CAMDEN COUNTY PLANNING BOARD
Land Development Review

Review List for Meeting

**CAMDEN COUNTY PLANNING BOARD
COUNTY ENGINEER'S REVIEW
OF SUBDIVISIONS AND
SITE DEVELOPMENT PLANS**

**COUNTY PLAN:
SP-8-9-18**

PRELIMINARY/FINAL MAJOR SITE PLAN & SUBDIVISION
 BLOCK 551.06, LOT 1
 BLOCK 551.06, LOT 1
 BRANCH VILLAGE PHASE III
 OVERALL LAYOUT PLAN
 SITUATED IN
 CAMDEN CITY, CAMDEN COUNTY, NEW JERSEY

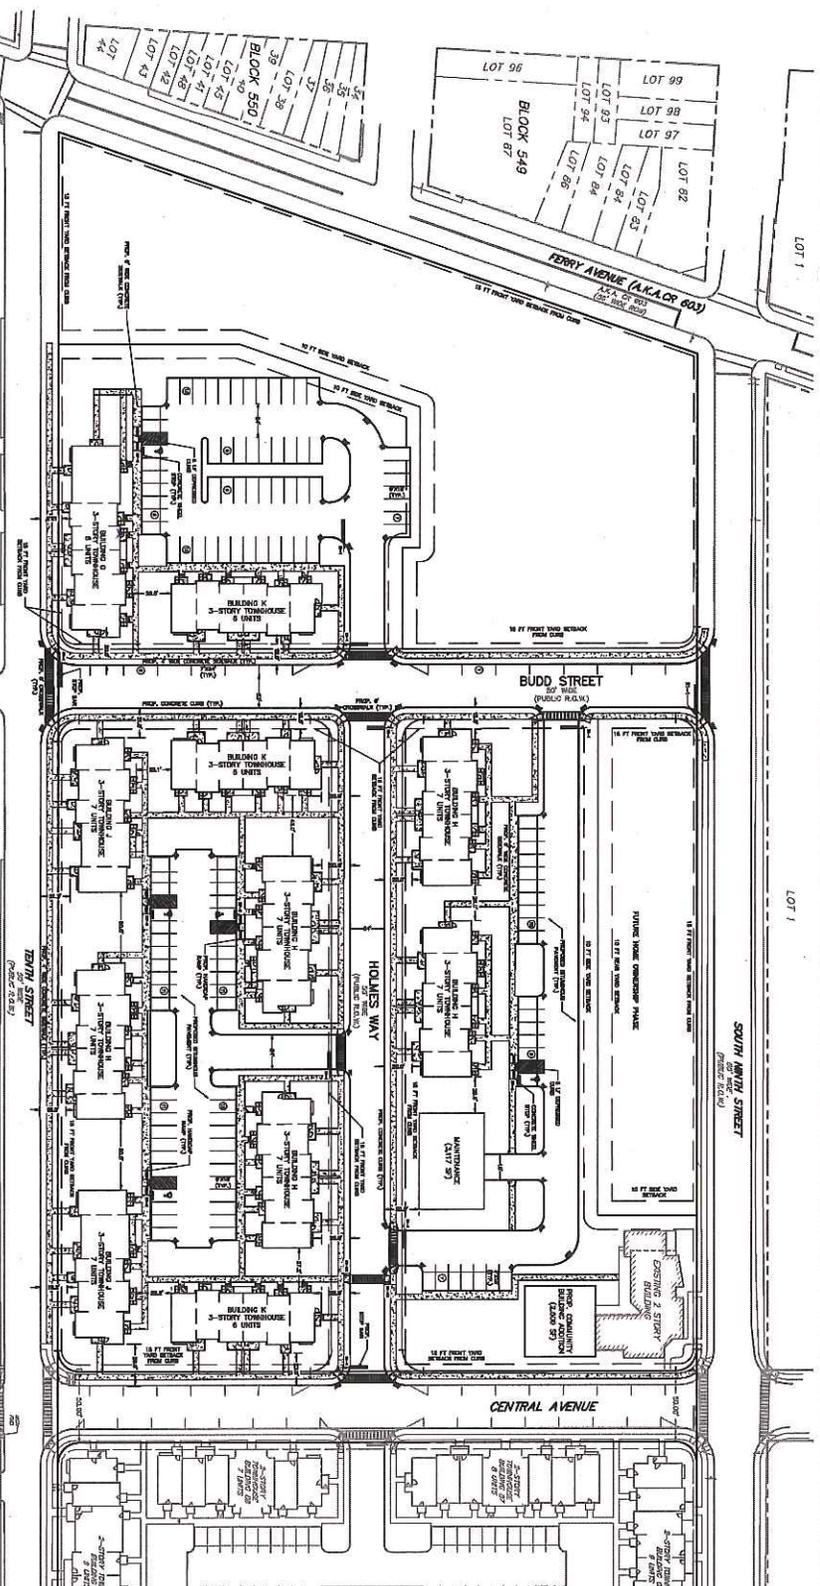
Subdivision and Site Plan - MJ-8-1-18/SP-8-10-18 - Camden county Planning Board does not have comments as this is not on a County Rd and does not impact County owned Stormwater Facilities. State law require the review and approval of all subdivisions and site plans that propose "multifamily structures containing five or more units" NJSA 40:27-6.6
